**CITY OF COLORADO SPRINGS
DOWNTOWN REVIEW BOARD
Meeting Minutes**

**The Downtown Review Board (DRB) held its regular meeting on
Wednesday, February 5, 2014
in the
City Council Hearing Chambers
107 N. Nevada Avenue, Suite 325
Colorado Springs, CO 80903**

DRB DP 14-00004
210 Pueblo Apartments

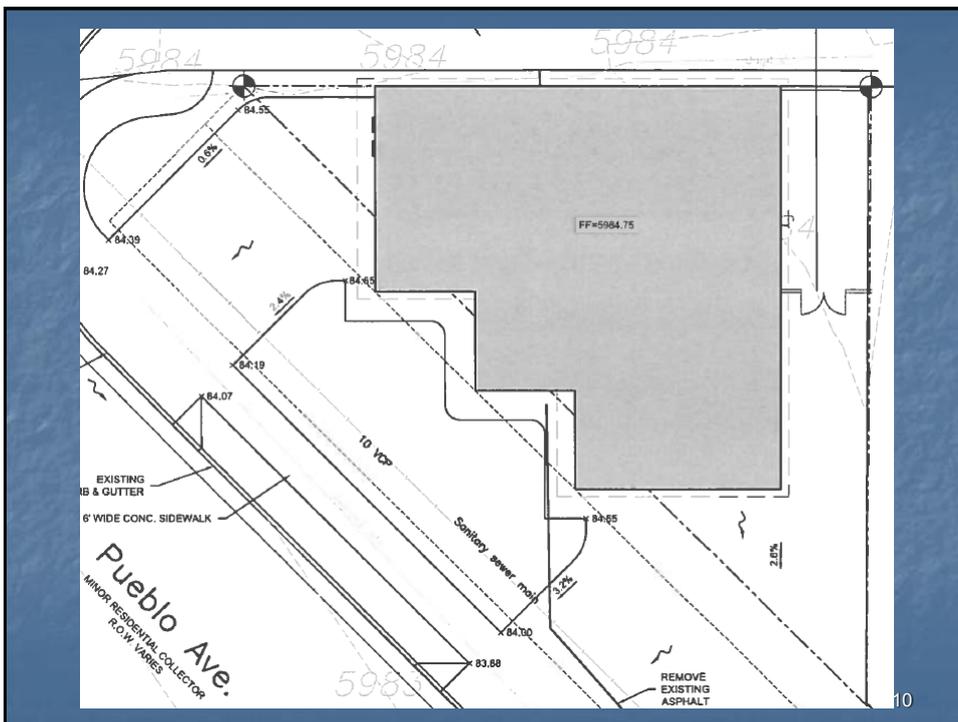
- FBZ focuses on building form issues, such as building placement, bulks/scale, and façade design
- Key issue for this site – building envelopes
 - Apartment buildings required to be placed within 15 feet of front property line
 - Presence of sanitary sewer main and utility easement prevent compliance
